Ventura County Community College District

DATE: May 15, 2025
TO: All Bidders
FROM: Spencer Herson, Purchasing Specialist
SUBJECT: Addendum 1 – Bid 709, Ventura College Stem Program Building Improvements

Drawings: Changes and clarifications noted as Addendum 01 and dated 05/15/25

SHEET NUMBER: **C3.1**
DATE: 5 OF

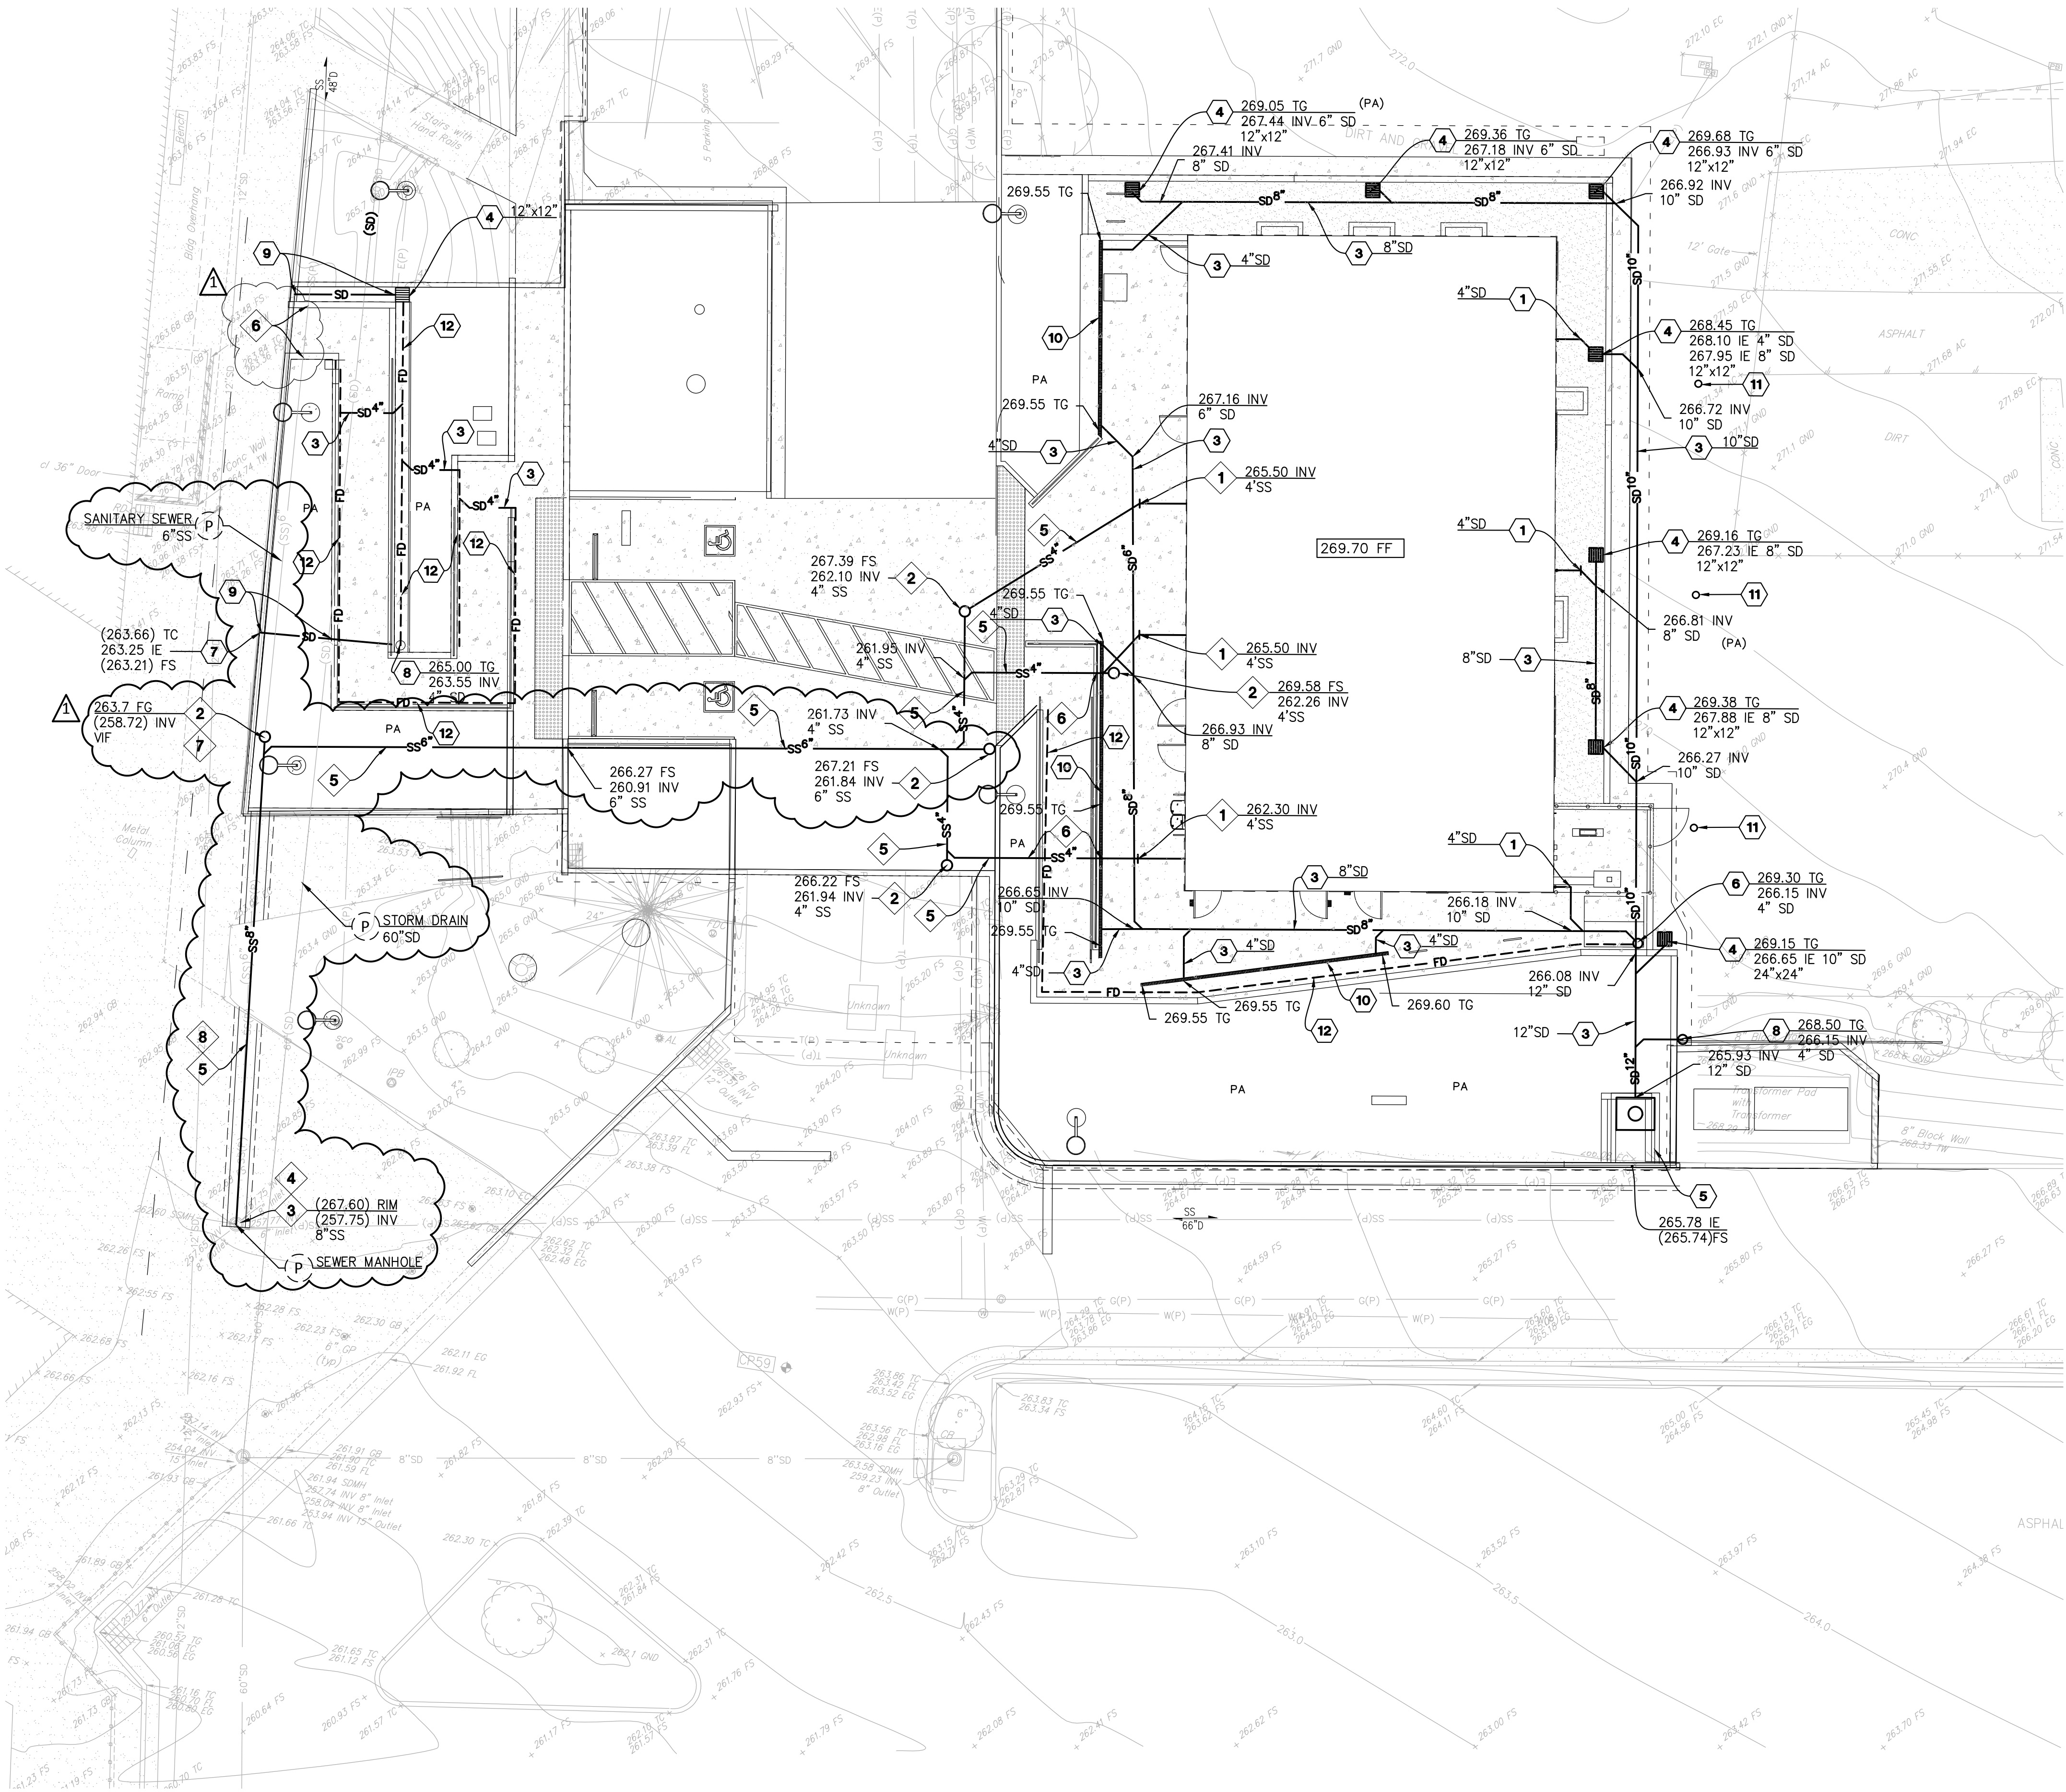
C3.1 – GRADING PLAN FOR DROP-OFF AREA

UTILITY PLAN
SANITARY SEWER
AND STORM DRAIN

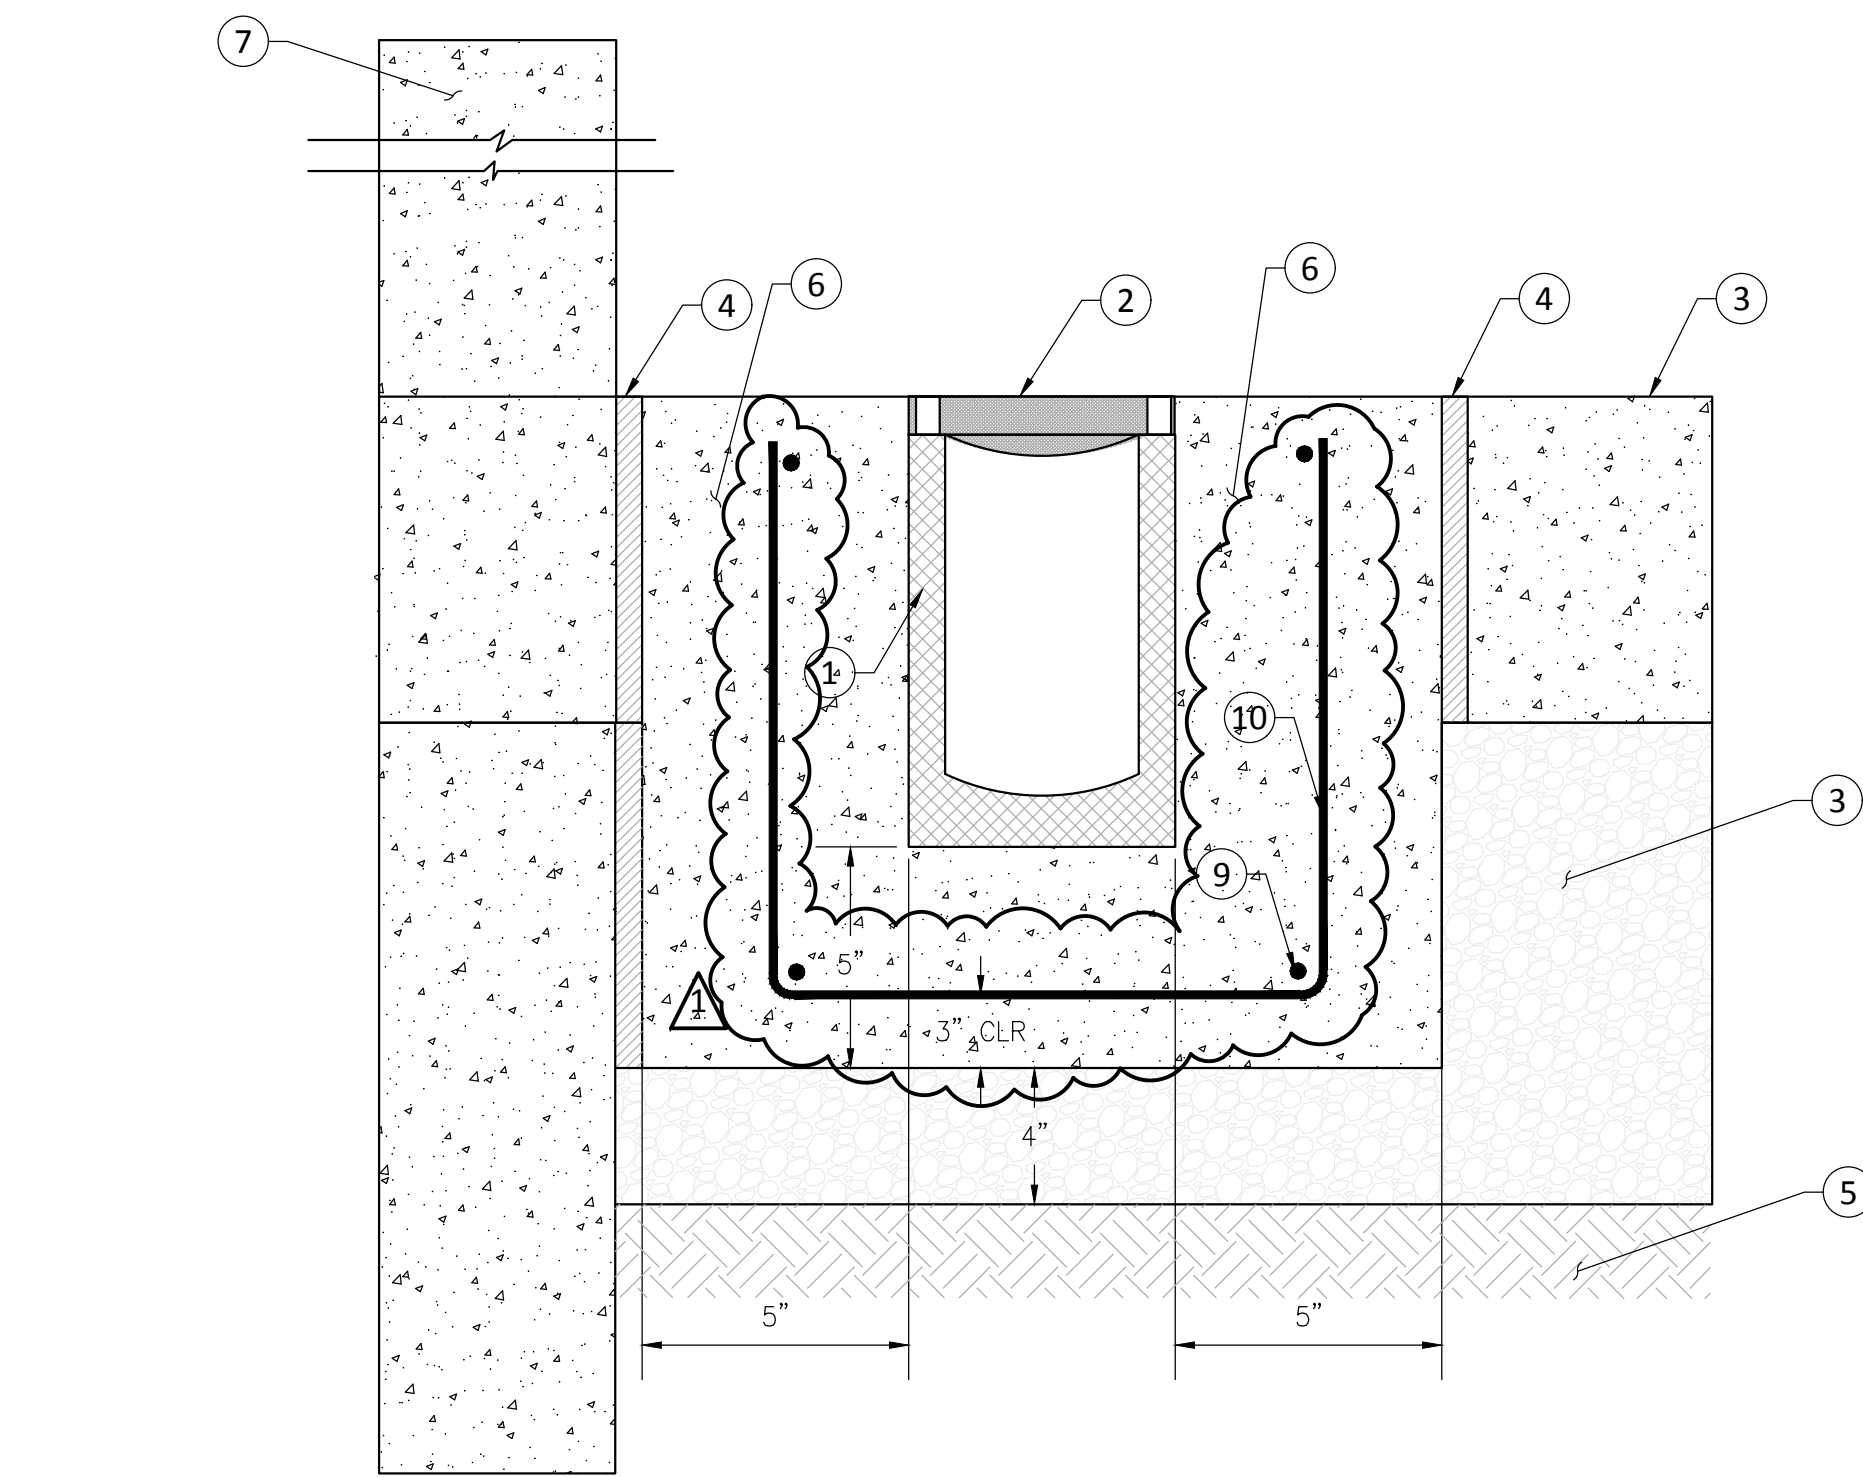
C4.0 – REALIGN NEW 6” DIAMETER SANITARY SEWER AND CLEANOUT, CONNECT TO EXISTING 6” DIAMETER SANITARY SEWER WITH CLEANOUT, REVISED SANITARY SEWER KEYNOTE 6, ADDED SANITARY SEWER POINT OF CONNECTION KEYNOTE 7, ADDED KEYNOTE 8, ADDED GENERAL NOTE FOR CONTRACTOR

TRENCH DRAIN

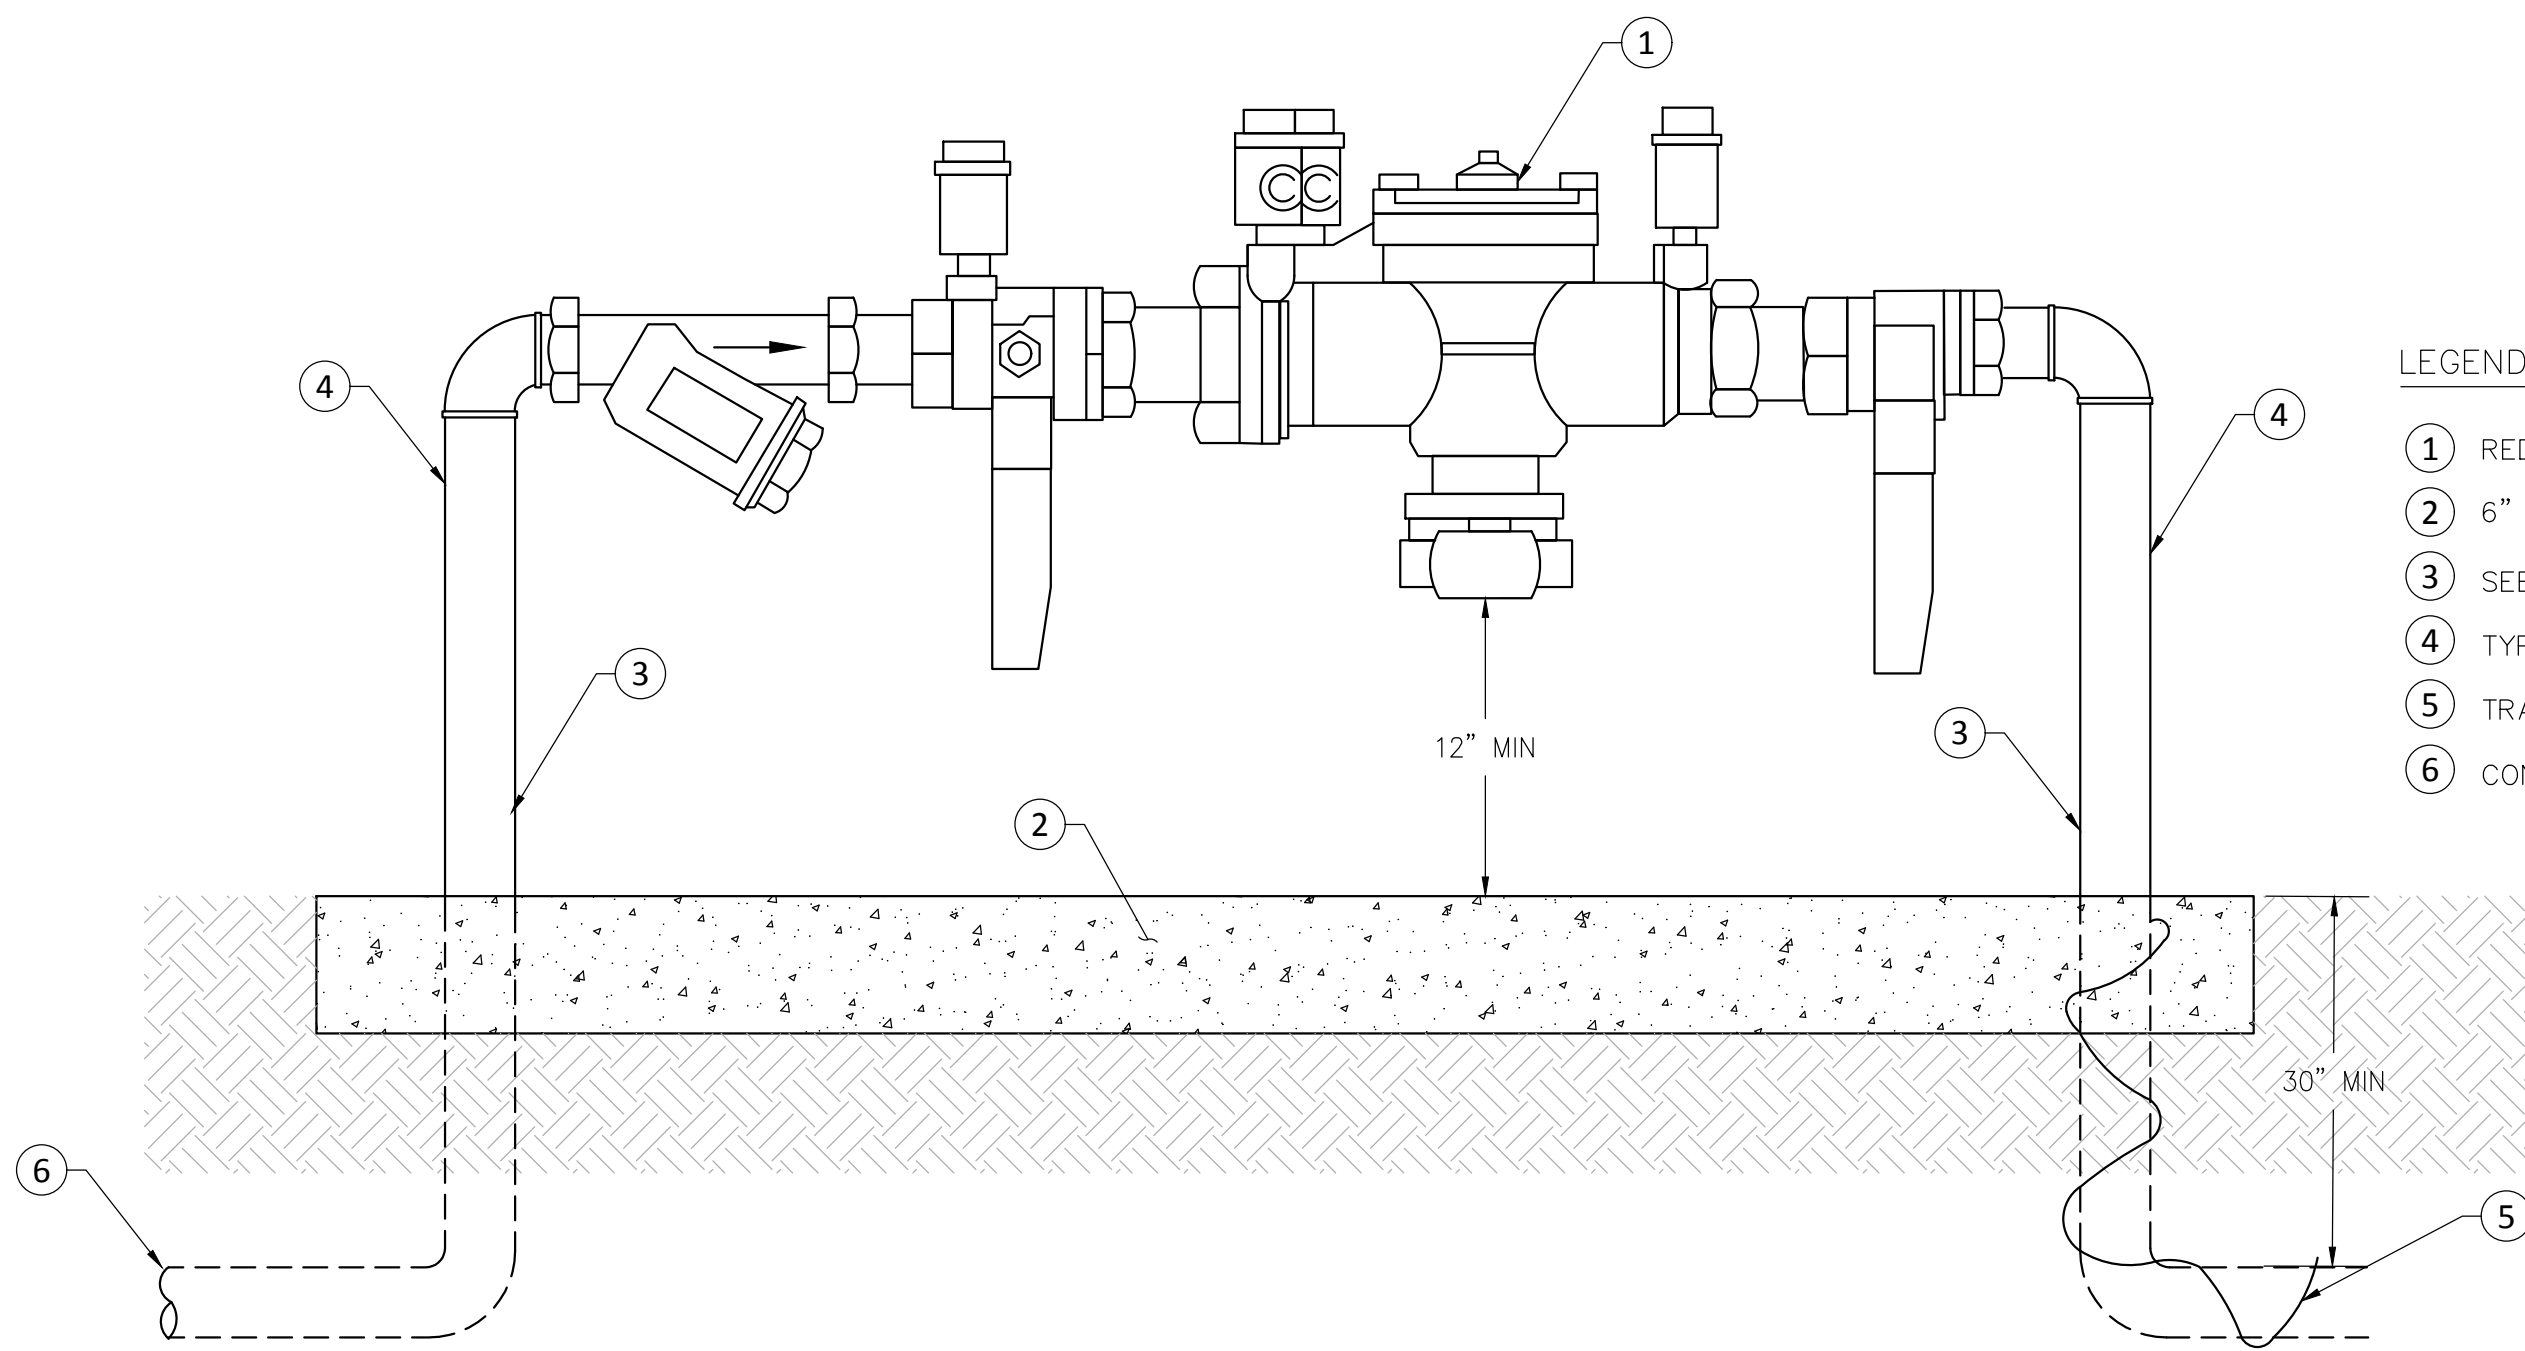
C5.1 – ADDED REINFORCEMENT TO TRENCH DRAIN DETAIL 12/C5.1, NEW CONCRETE V-GUTTER DETAIL 18/C5.1
